Photographic Log

Facility Name:	Site Location:	Tracking No.:	Date:
Shelby Farms Park, Heart of the Park	Shelby Farms Park	TN0081663	12/11/2015

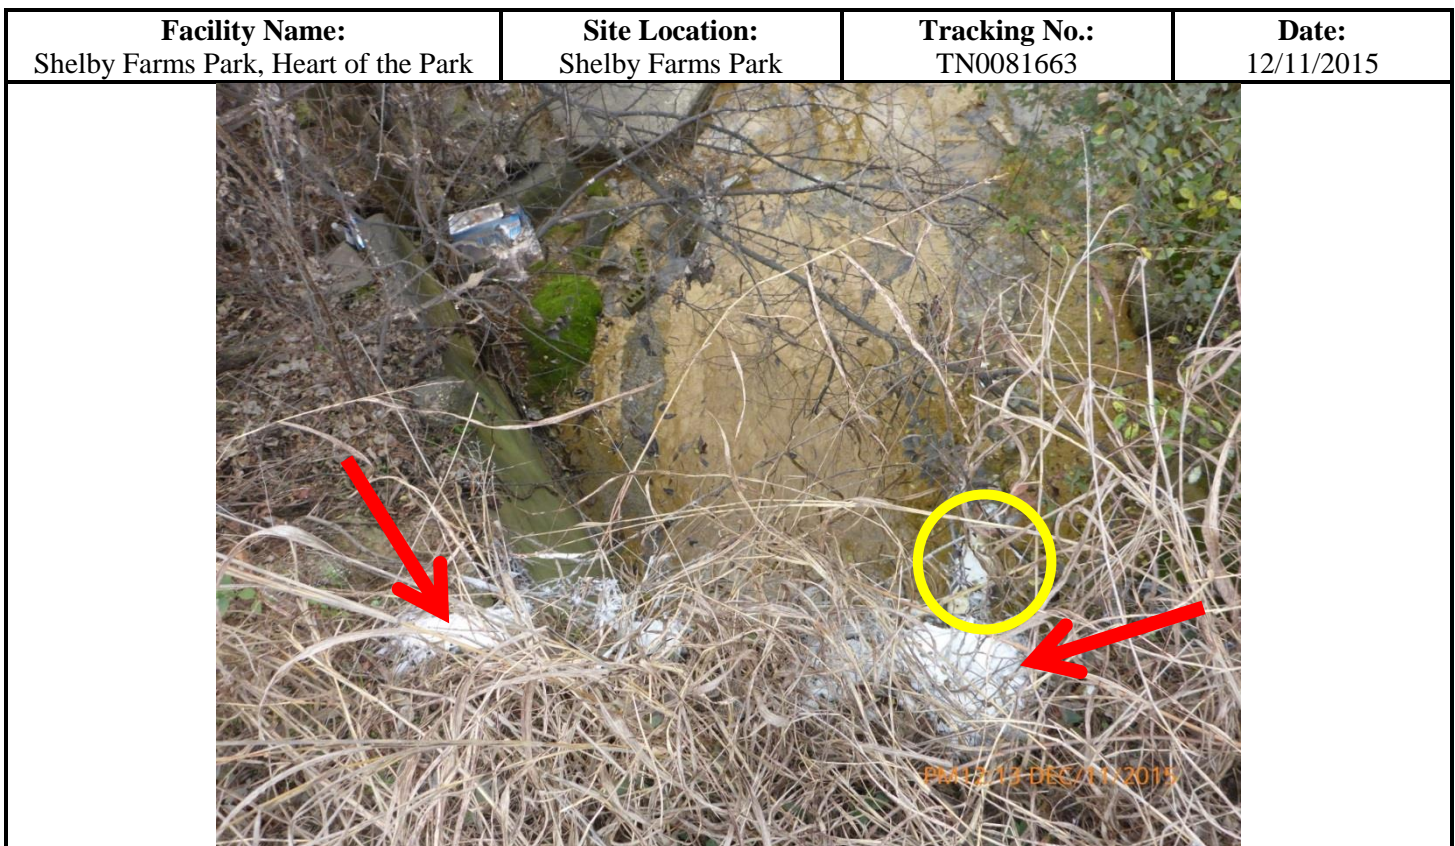
Photo 6. Residual polyacrylamide (PAM) on the top of the ground above the drainage culvert where it was applied to the drainageway downgradient of outfall SW9. Some PAM can also be seen within the channel (yellow circle). Applying PAM downgradient of the sediment basin is prohibited in the *TN Erosion Prevention and Sediment Control Handbook*.
